RE: DA2024/1216 – North Harbour Marina

NORTH HARBOUR MARINA – DA CONCERNS

Development Application Number: DA2024/1216

11. SYDNEY HARBOUR CATCHMENT – SYDNEY REGIONAL ENVIRONMENTAL PLAN 2005

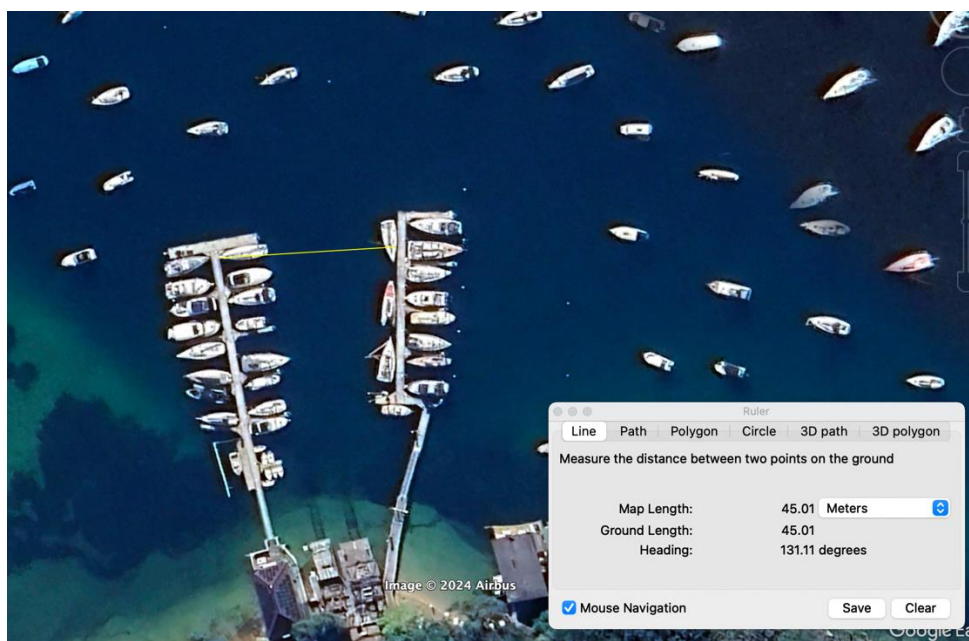
- NHM is located within Zone W2 – ‘Environment Protection’. The purpose of the zone W2 is:

- The Zone W2 – Environment Protection provides for the protection, rehabilitation and long term management of the **natural and cultural values of the waterways and adjoining foreshores**. The zone covers a range of areas including significant estuarine ecosystems and habitats in parts of Manly Cove and Middle Harbour, estuarine and wetlands habitats along the Parramatta River, and significant riverine environments of the Lane Cove River and Duck Creek.
- This proposal clearly does not adhere to the purpose and aim of this Zone.
- North Harbour Marina is the **ONLY marina within the Zone M2** and therefore should be held to the highest level of scrutiny.
<https://www.planning.nsw.gov.au/sites/default/files/2023-03/sydney-harbour-catchment-sydney-regional-environmental-plan.pdf>
